To: INCITS Technical Committee T10  
From: Kevin Butt  
Date: September 4, 2007 7:29 pm  
Document: T10/07-374r2 — SSC-3: End-to-end Logical Block Protection

Please see SSC-3: Tape end-to-end data protection (Presentation) (07-373r2) as the introduction to this proposal.

**FIGURE 1. Protection information shown in relation to logical objects and format specific symbols**

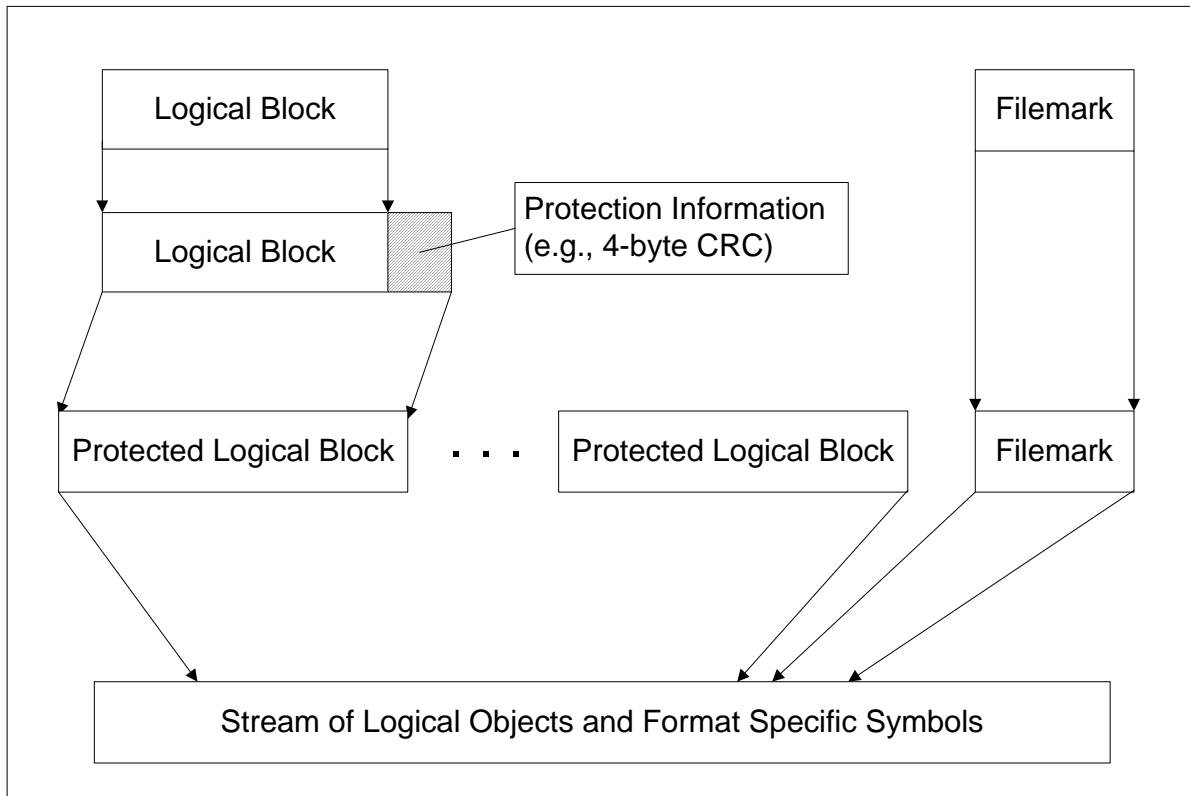
**QUESTION:** Should there be added the option to allow a Transform of the protection information into some format specific protection information that is instead saved to medium? This would allow us to require the same RS CRC protection information for all devices (and only require HBAs to support the one algorithm). This would also allow a path from today to the future for those formats that do not include the CRC algorithm(s) supported.
